JAMES A. FITZPATRICK NUCLEAR POWER PLANT

AMENDMENT TO FACILITY OPERATING LICENSE

Amendment No. 43
License No. DPR-59

ATTACHMENT TO LICENSE AMENDMENT NO. 43

FIGURE 1.1-1 APRM FLOW BIAS SCRAM RELATIONSHIP TO NORMAL OPERATING CONDITIONS

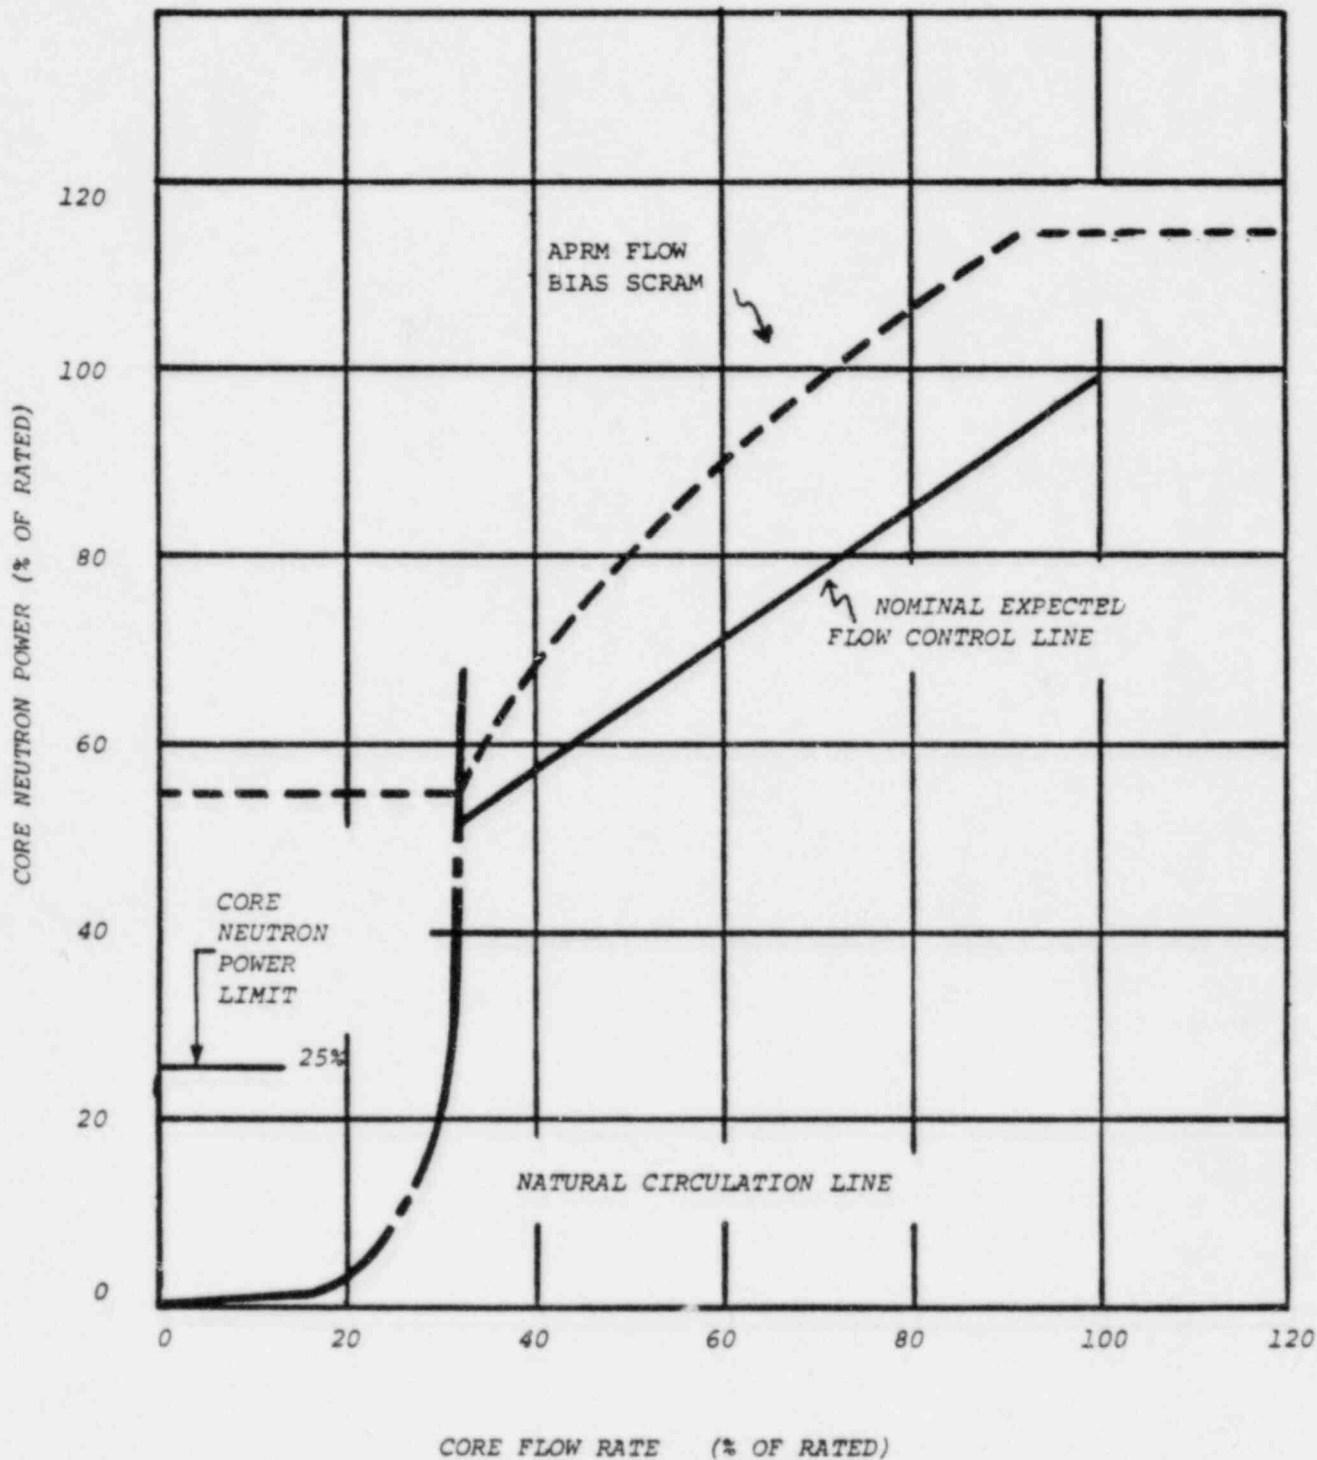
$$S \leq 0.66 W + 54\%$$

13. The Average Power Range Monitor scram function is varied (Figure 1.1-1) as a function of recirculation loop flow (W). The trip setting of this function must be maintained in accordance with Specification 2.1.A.1.c.

FIGURE 3.5-5 MAXIMUM AVERAGE PLANAR LINEAR HEAT GENERATION RATE
(MAPLHGR) VERSUS PLANAR AVERAGE EXPOSURE

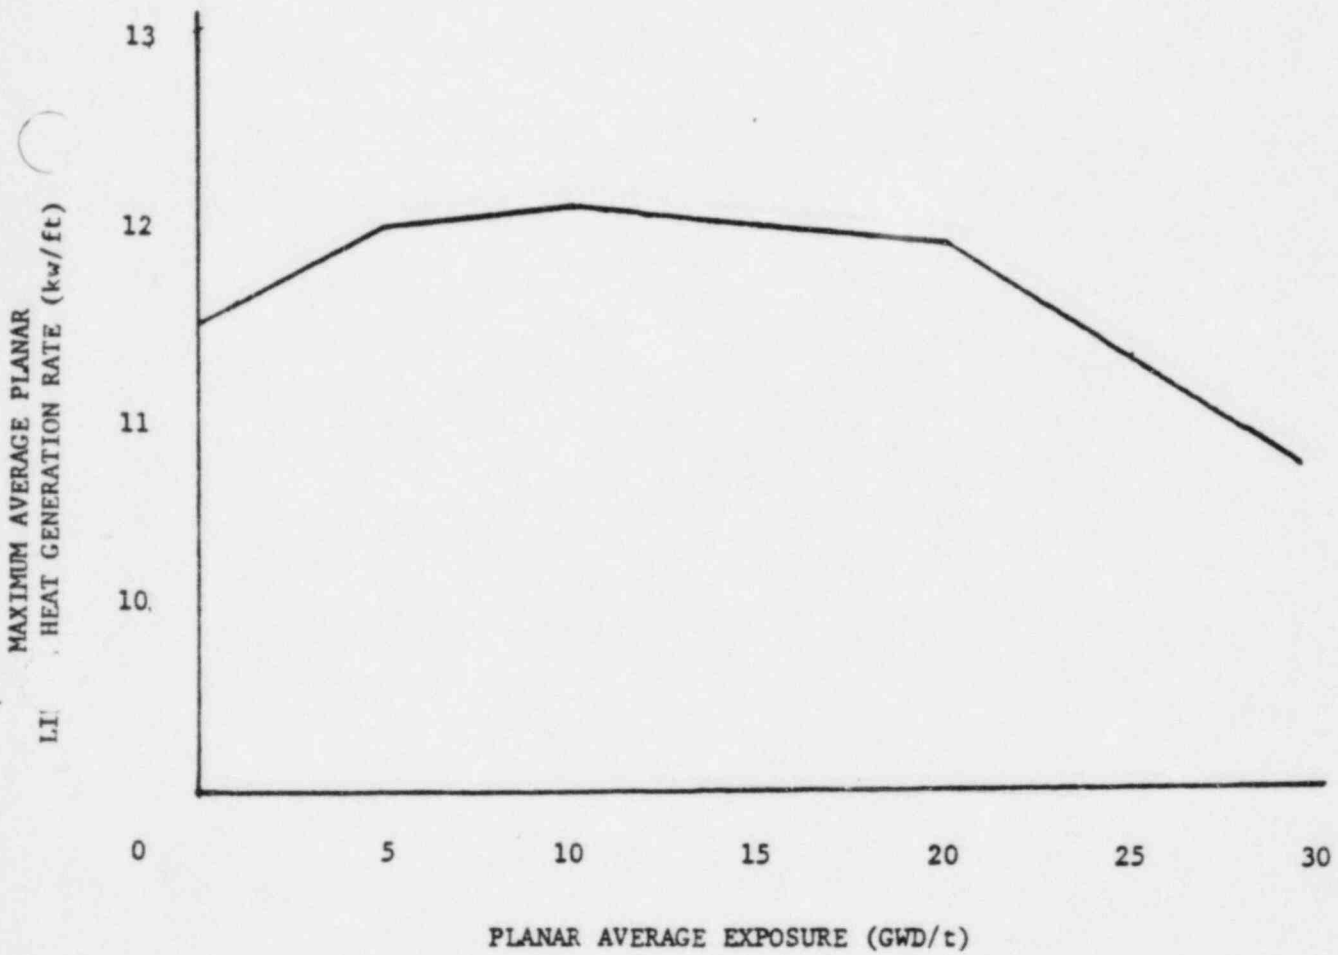
The APLHGR for each type of fuel as a function of average planar exposure shall not exceed the limiting value shown in Figures 3.5.1 through 3.5.6. If anytime during reactor power operation greater than 25% of rated power it is determined that the limiting value for APLHGR is being exceeded, action shall then be initiated within 15 minutes to restore operation to within the prescribed limits. If the APLHGR is not returned to within the prescribed limits within two (2) hours, an orderly reactor power reduction shall be commenced immediately. The reactor power shall be reduced to less than 25% of rated power within the next four hours, or until the APLHGR is returned to within the prescribed limits.

are within the 10 CFR 50 Appendix K limit. The limiting value for APLHGR is shown in Figure 3.5.1 through 3.5-6.
